MEMORANDUM

RE: DRAFT PLAN OF SUBDIVISION APPLICATION (COUNTY FILE NO. 07-T-10005) – LOCKMASTER’S MEADOWS SUBDIVISION, CARDINAL, ON

Re: Peer Review: Rail Noise Assessment
LOCKMASTER SUBDIVISION
Gradient Wind Engineers & Scientists, dated July 21, 2021
Greer Galloway File No: 21-3-5536

Figure 2: Proposed Draft Plan of Subdivision Revision 2021

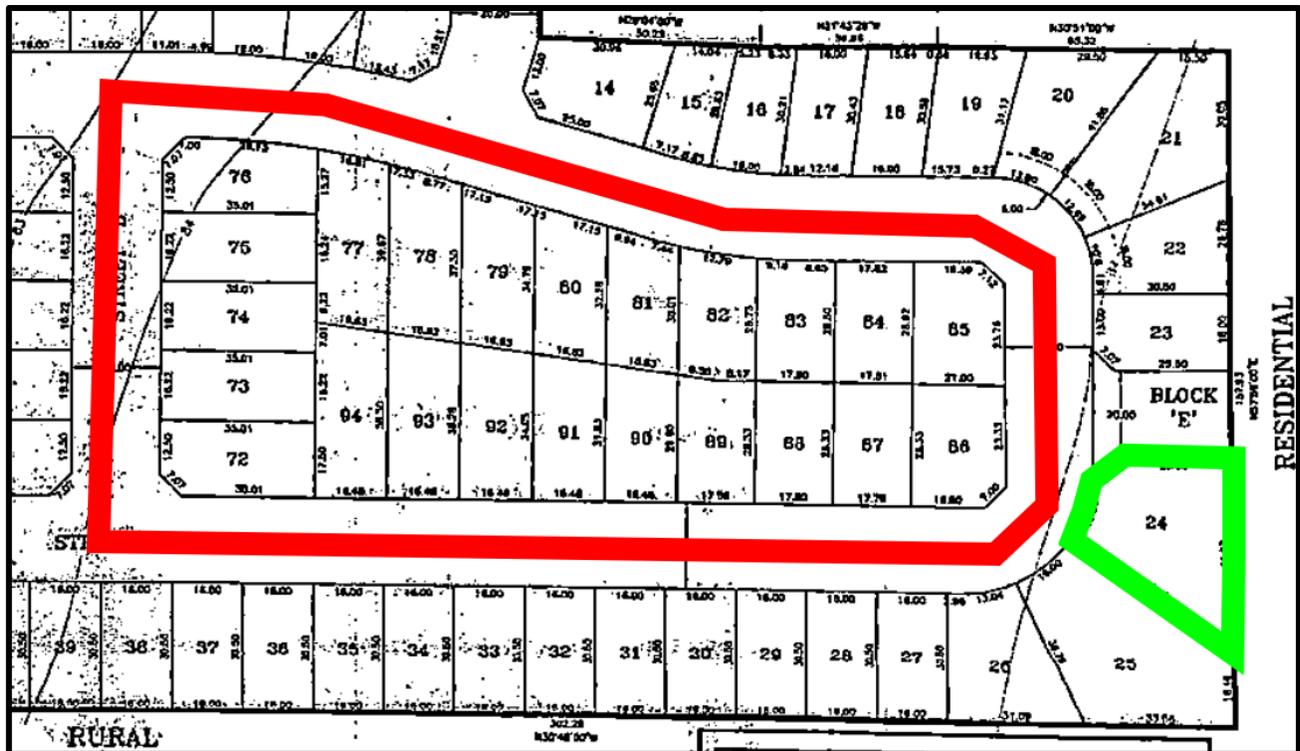
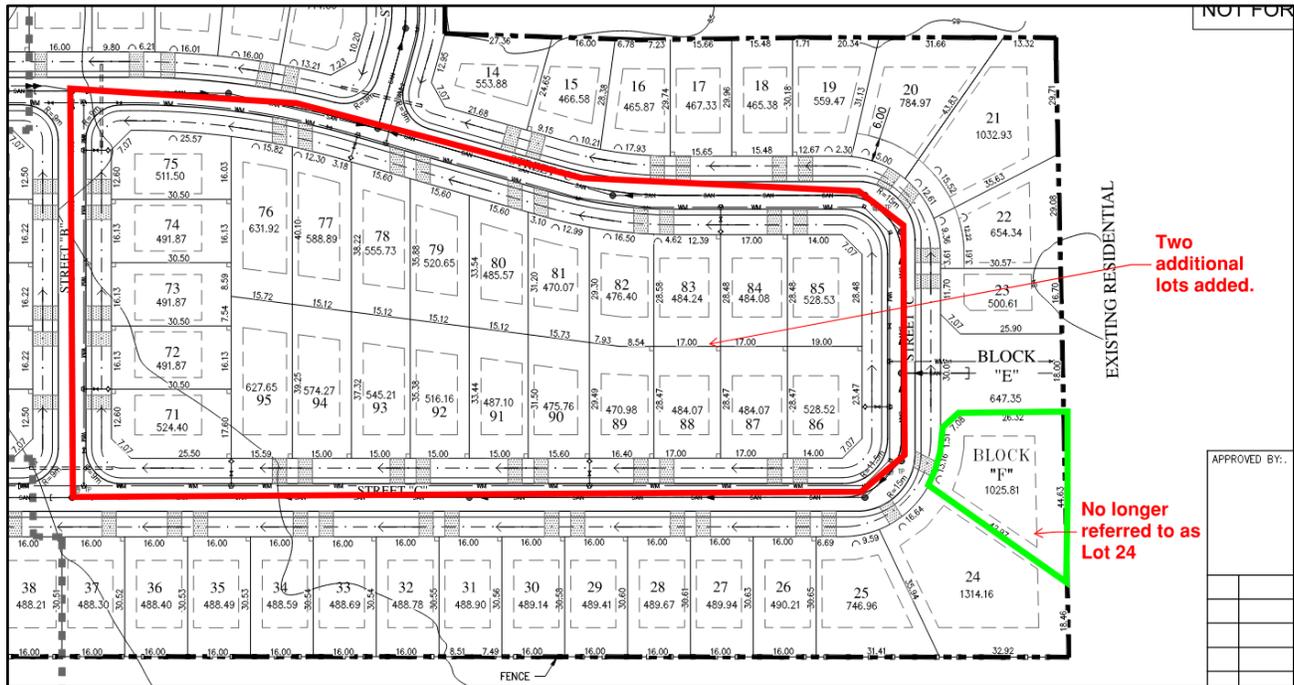
In comparison to the draft-approved subdivision in 2013, the revised 2021 application maintains the same street configuration and blocks for open space/parkland/reserve purposes. The revised application proposes to increase the residential density through 2 new additional lots for single detached dwellings (Figure 1 and Figure 2). The revised subdivision is proposed to be built in two phases as shown on the draft plan with the first phase including lands south of Street B for a total of 59 residential lots.

In addition to the minor increase in residential lots, the proposed application includes a request to reduce the noise attenuation conditions imposed on the subdivision due to the proximity to the railway. This request includes removing a proposed berm which has been supported by the applicant through a Rail Noise Study prepared by Gradient Wind. The Township has requested that the noise study be peer-reviewed to ensure an appropriate review of the request is undertaken. Further, a Traffic Impact Study was submitted to clear condition #45 associated with the draft approved plan from 2013.

It is recommended that a future right-of-way between the subject lands and adjacent lands to the west be provided. A future right-of-way is important when considering future development opportunities and good land use planning from a transportation circulation and emergency services perspective. It is recommended that the applicant explore the feasibility of a future right-of-way block (minimum 20 m wide) to be transferred to the Township at the end of either Street B between Lots 37 & 38 or Street D between Lots 46 & 47. The requirement for a future access block could be included as a new condition of draft approval.

provided in Attachment 4. A condition requiring an access block to the abutting lands to the west could be added as a condition or added to the revised draft plan.
